Environmental Impact Assessment

Schedule III

ERA Reference no.:	EA/00075/18
PA Reference no.:	PA/01103/18
Project Title:	Excavation of trenches for the laying of pipework and cables for the new water distribution system. To include the installation of water dispensers along the routes.
Location:	Various Roads at, Tal-Bidni, Habel I-Abjad, Tas-Silg, Xghajra, San Anard, Sant'Antnin, M'Xlokk, Zabbar Zabbar, Xghajra, San Anard, Sant'Antnin, Zabbar, M'Scala, Xghajra, M'Xlokk, Bulebel, Zejtun, Malta
Screening date:	December 2018

Figure 5: Shows the area where Dispensers 56005 – 27 and 56005 – 28, 56005 – 29 will be located

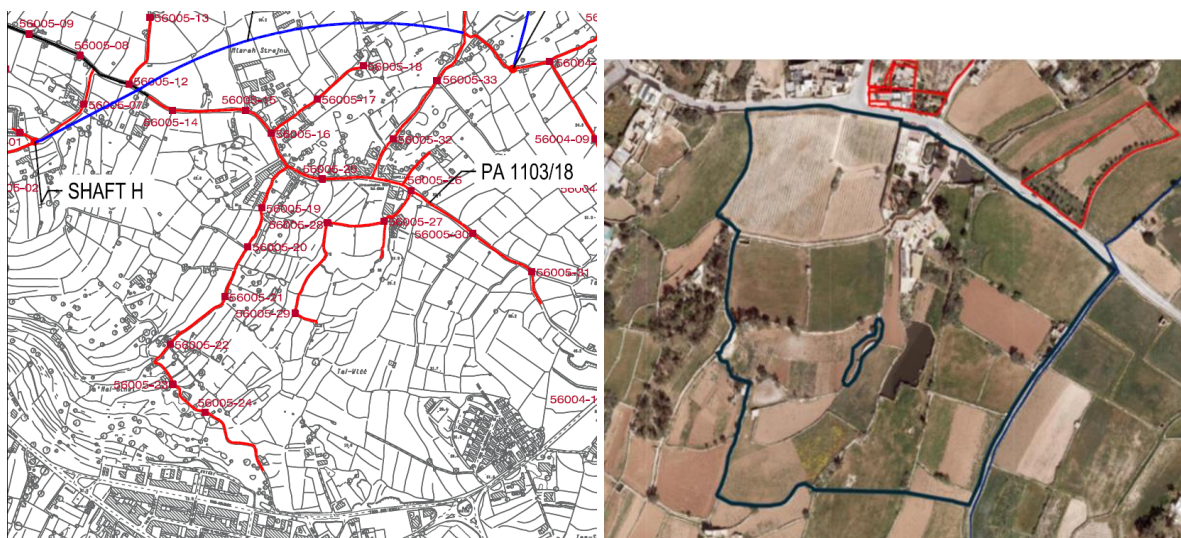
The below area is scheduled as Class A, Site of Archaeology Importance (SAI) for Hal Ginwi Temple as per G.N 1082 of 2009. ERA has its reserve on Dispenser 56005 – 27 and manhole M48 and is not convinced that the proposed installation and its ancillary infrastructure will not cause any damage to the environment especially when there is no existing path. With regard to the other two dispensers (56005 – 28, 56005 – 29) and manhole M47, these are located along a narrow and beaten path, which should remain as such without any trenching, concreting or hard surfacing. A clarification is being requested as to how the intervention will be carried out in a manner to avoid such adverse impacts so that the acceptability or otherwise of these specific works can be determined.

Figure 6 Shows Dispenser 56006 – 40
Source: PA Geoportal (Ortophoto 2016)

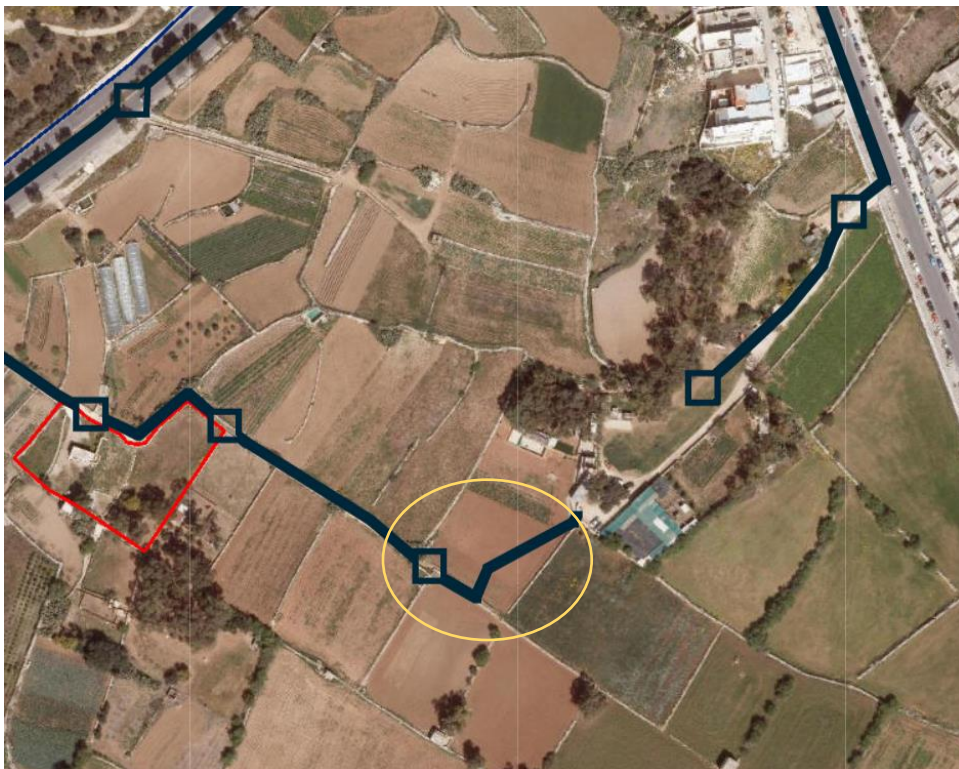
Both the Orthophoto 2016 and the Block Plan shows that trenching will occur on agricultural land and not within an already existing access. Hence ERA suggests the removal or relocation of Dispenser 56006 – 40 and the surrounding trenching in the yellow circle so that trenching is limited only to existing tracks.
